### Product Change Notice

Issue Date: 06-April-2021

Change of manufacturer location, change of product packing

**AFBR-S4N66C013**

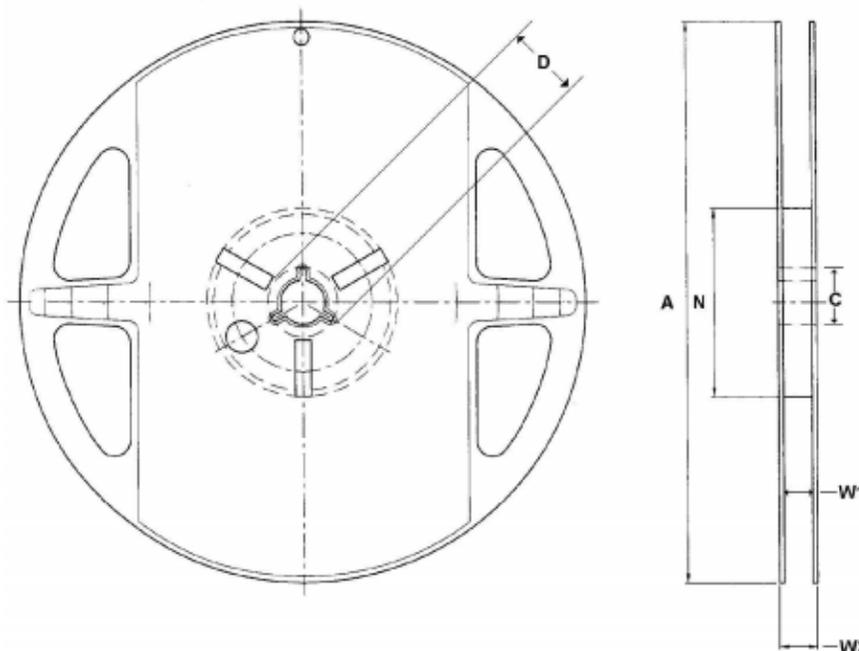
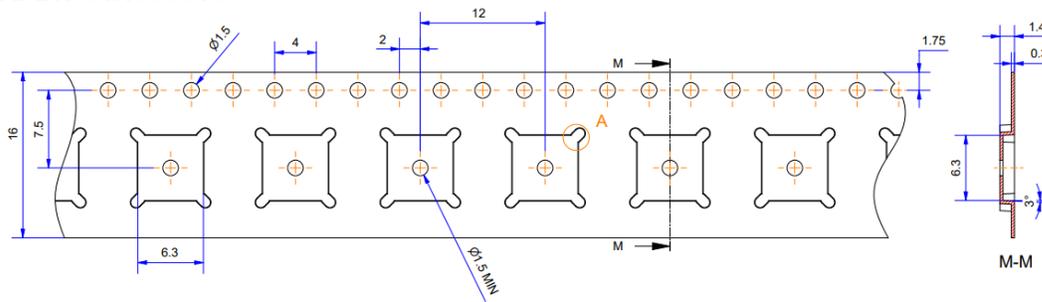
1. Activate additional manufacturing location.
2. Change product packing from waffle packing to reel packing:

Dimensions For Assembled EcoReel (All dimensions in mm)						
Tape Width	A (Diameter)	C	D (min)	N Hub	W1	W2 (max)
16	178 +/-1.0	13.5 +/-0.5	20.2	60 +0.1/-0.0	17 +/-0.5	19.5
All Other Dimensions and Tolerances are Fully Compliant With EIA 481-E

Each tape and reel contains 200 units.

### AFBR-S4N44C013

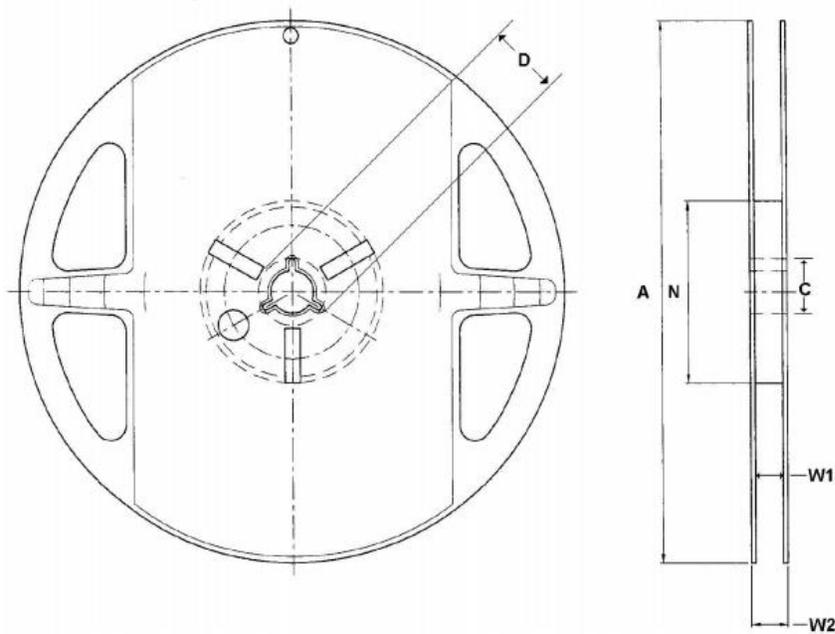
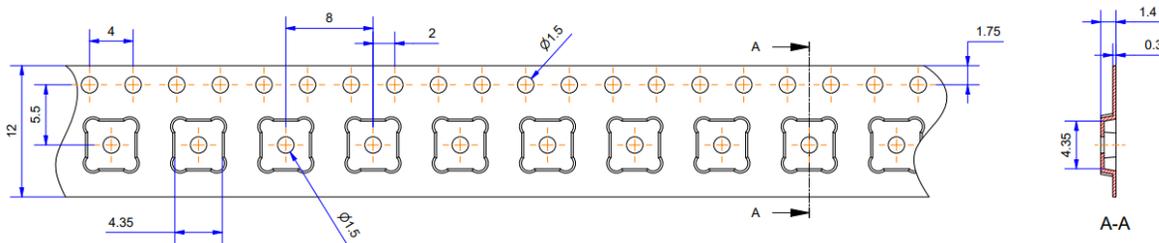
Dimensions For Assembled EcoReel (All dimensions in mm)						
Tape Width	A (Diameter)	C	D (min)	N Hub	W1	W2 (max)
12	178 +/-1.0	13.5 +/-0.5	20.2	60 +0.1/-0.0	13 +/-0.5	15.5
All Other Dimensions and Tolerances are Fully Compliant With EIA 481-E

Each tape and reel contains 500 units.
